ADMINISTRATIVE AMENDMENT

PROJECT
Las Lomas Plaza-Administrative Amendment
2101 Vista Oeste
Albuquerque, NM 87120

TITLE
Architectural Site Plan

1 North Elevation
Scale: 1/4"=1'

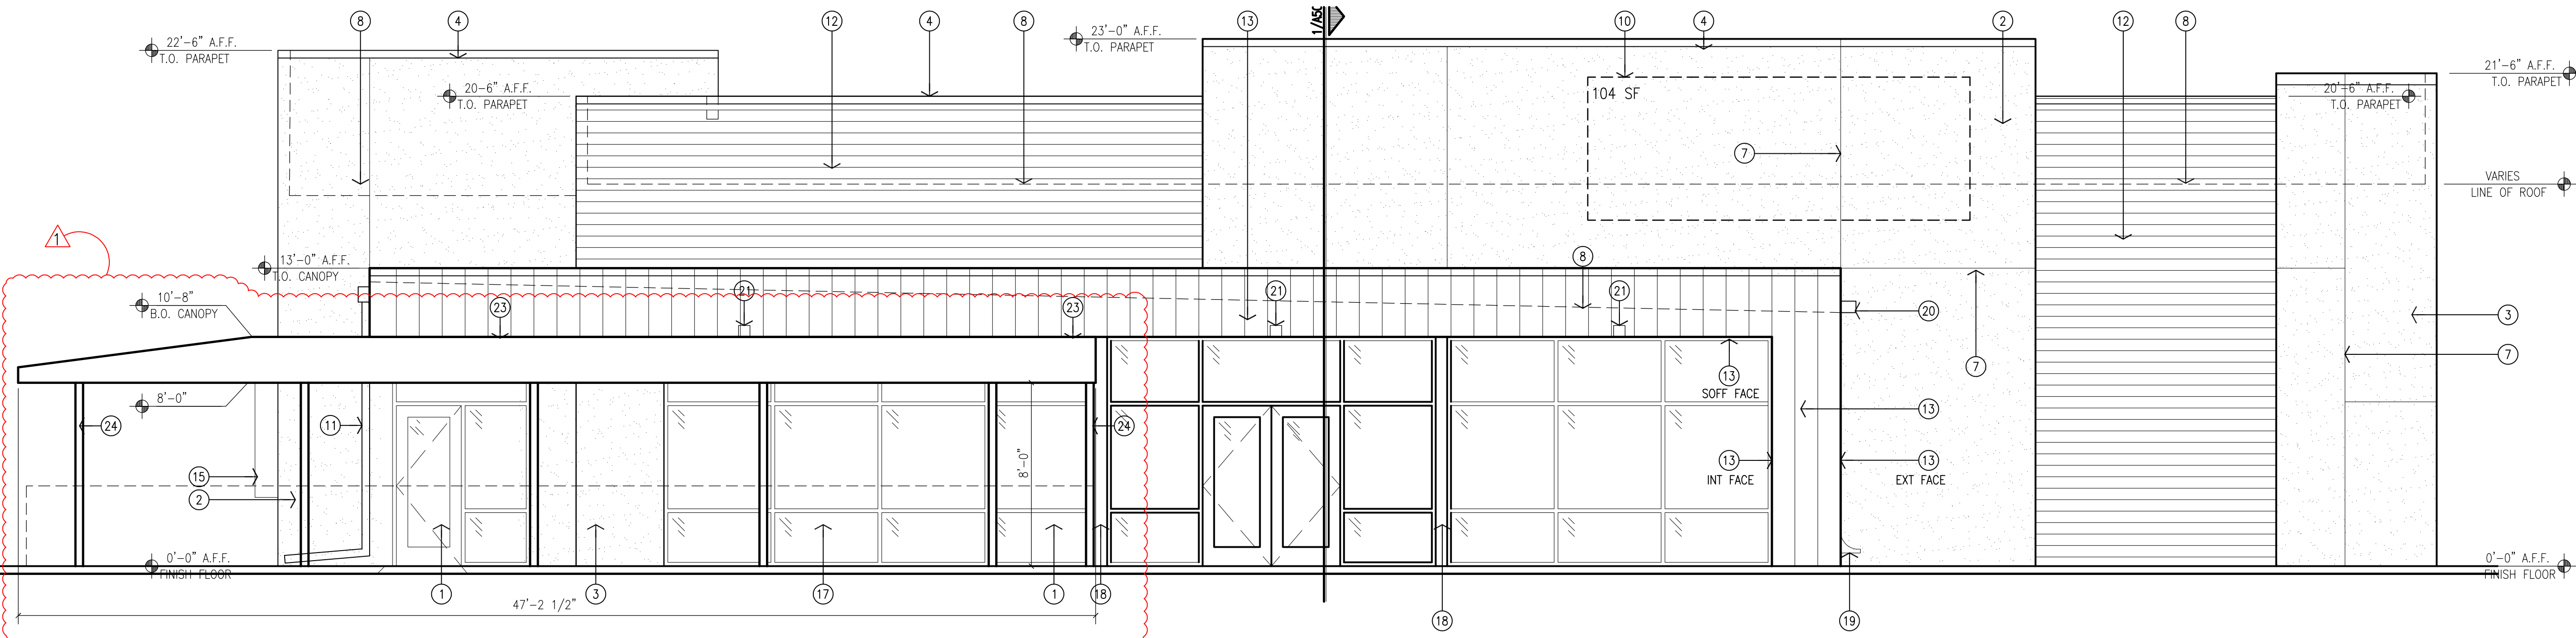
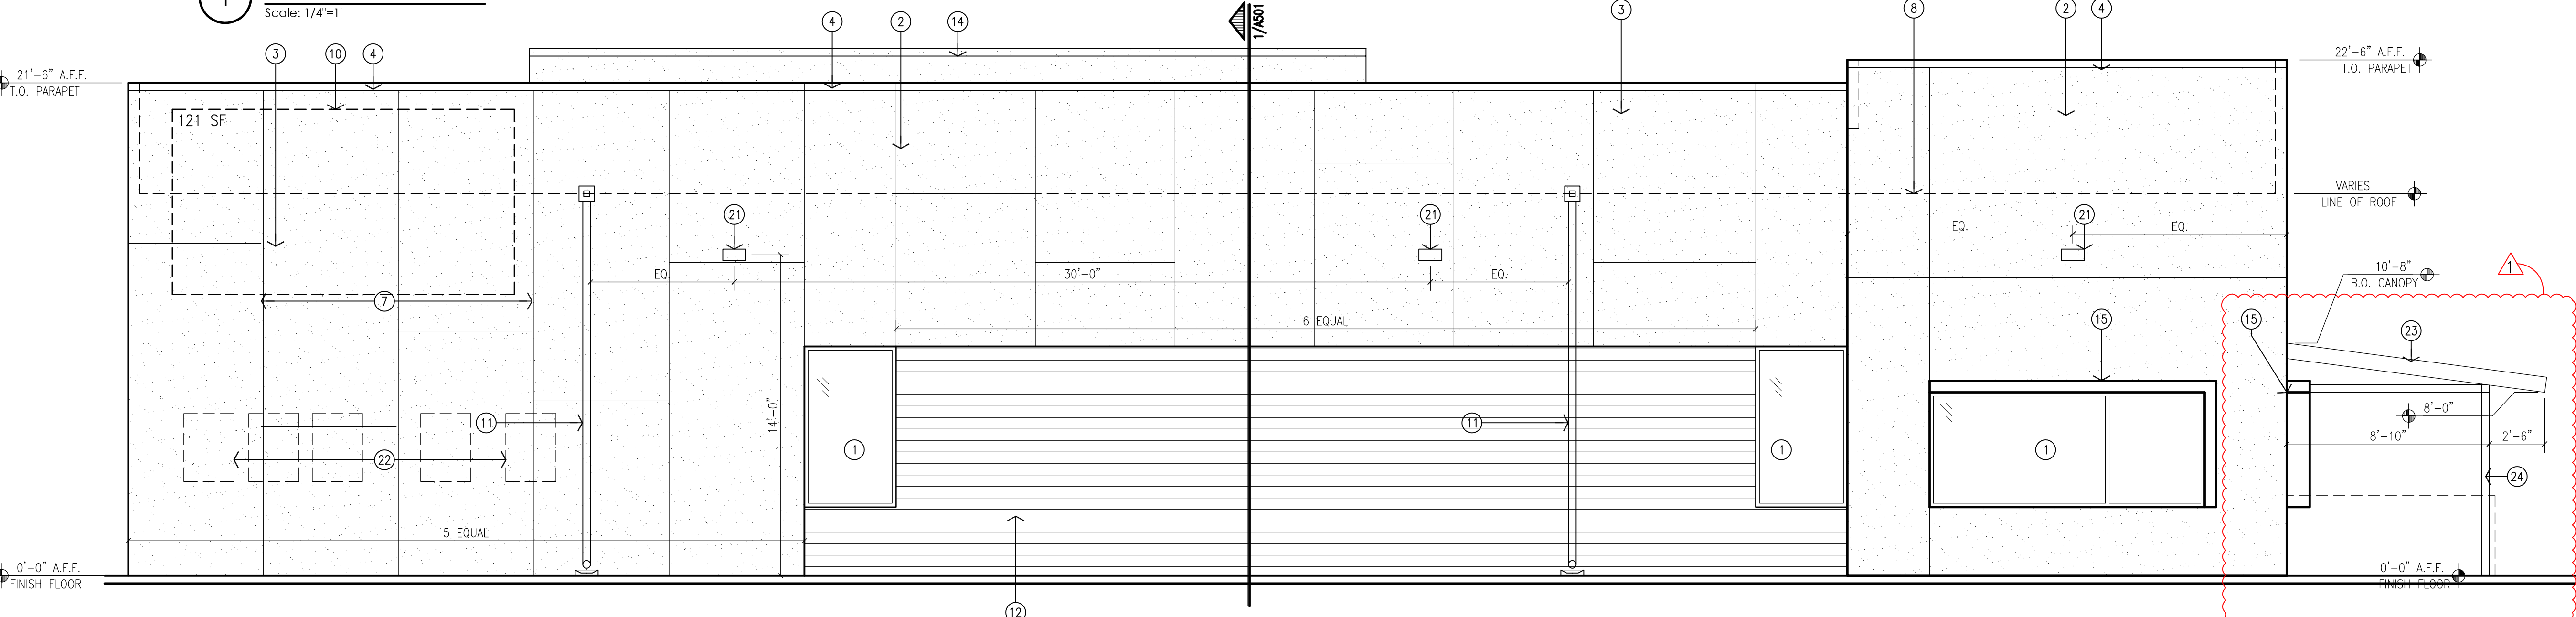
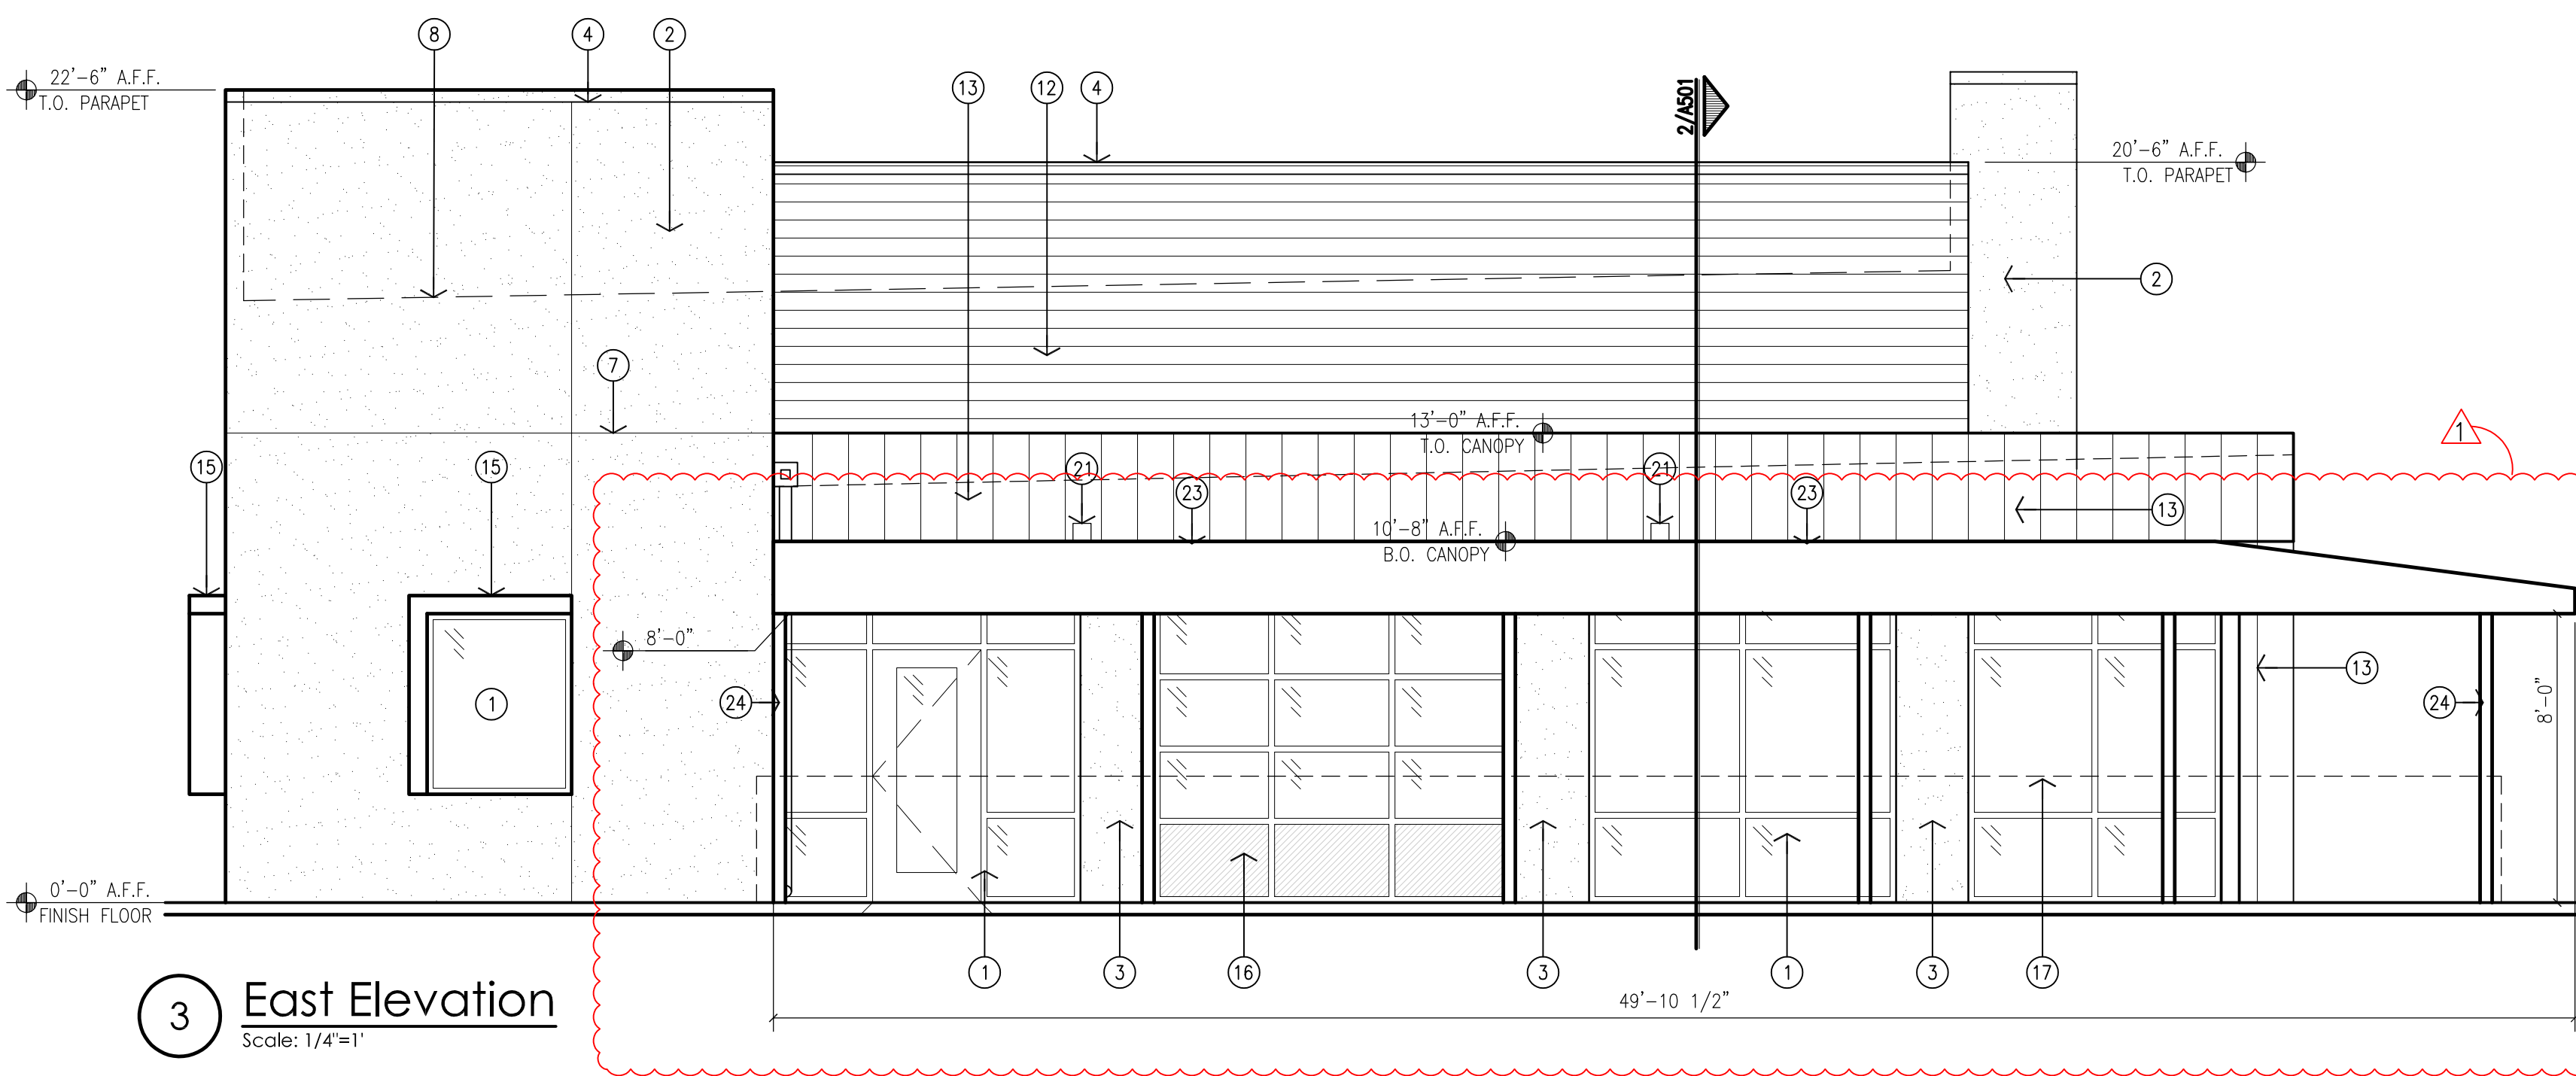
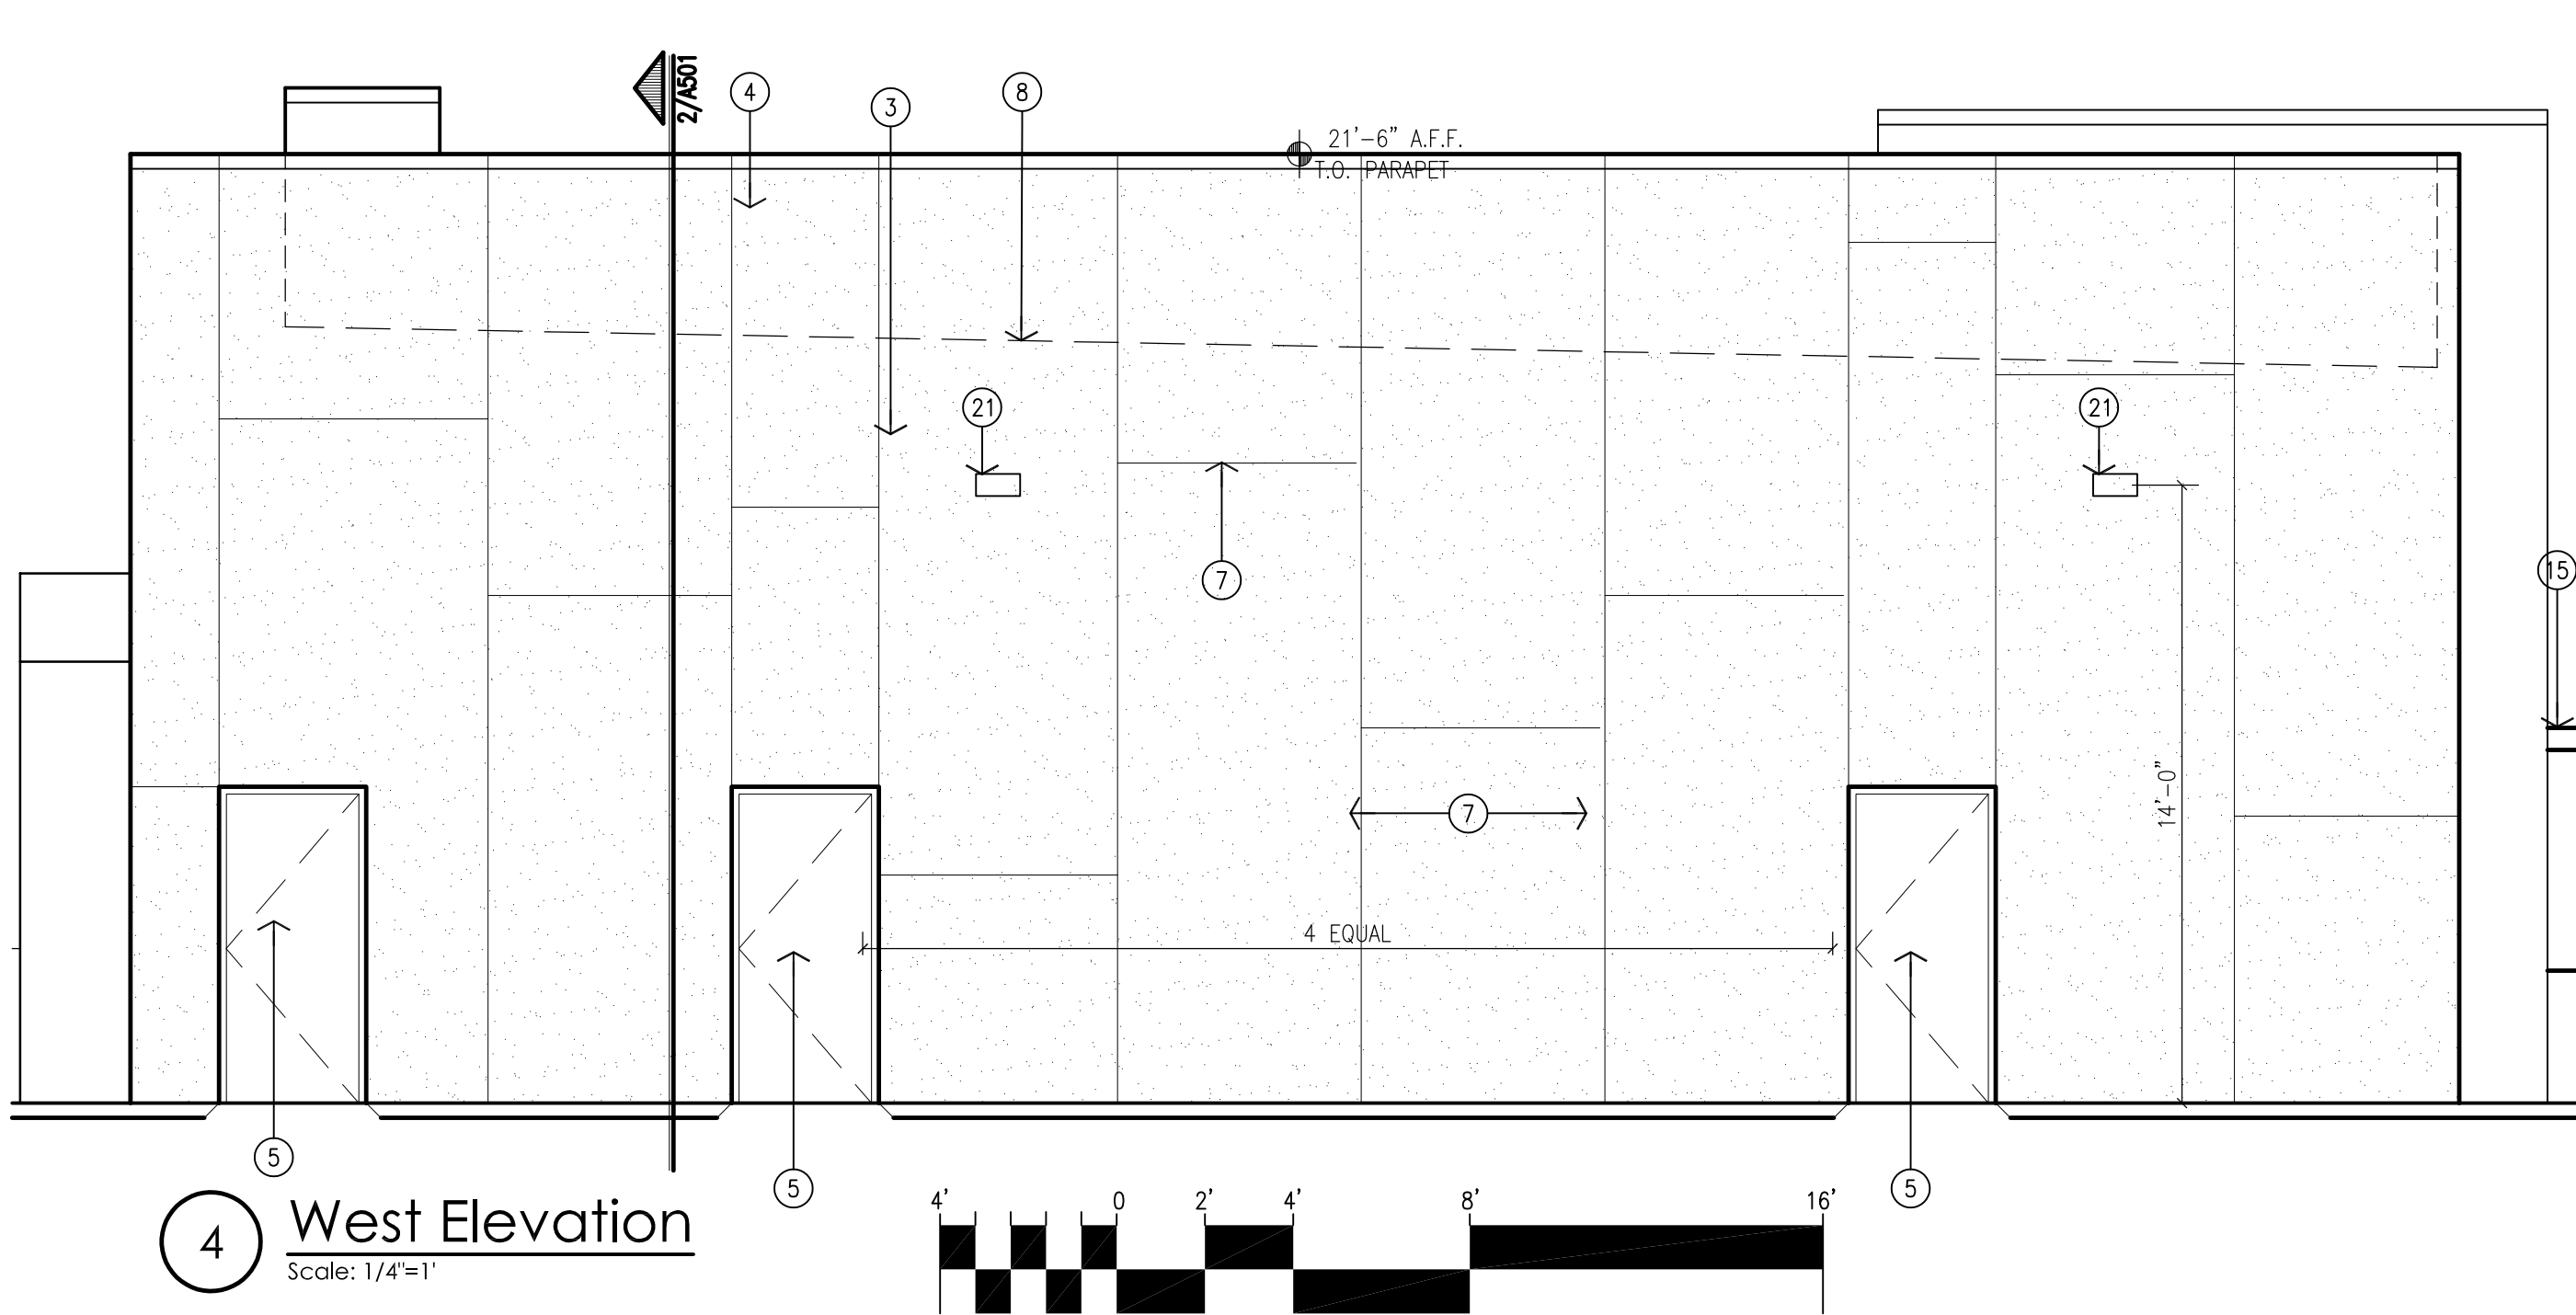
- [19] PREFINISHED SHEET METAL OVERFLOW SCUPPER.
 - [20] LIGHT FIXTURE. SEE ELECTRICAL.
 - [21] ELECTRICAL EQUIPMENT. SEE ELECTRICAL.
 - [22] NEW METAL CANOPY OVER EXISTING OUTDOOR PATIO. COLOR: DARK GRAY TO MATCH EXISTING.

- [23] NEW STEEL COLUMNS. REFER TO STRUCTURE.
 - [24] NEW STEEL COLUMNS. REFER TO STRUCTURE.
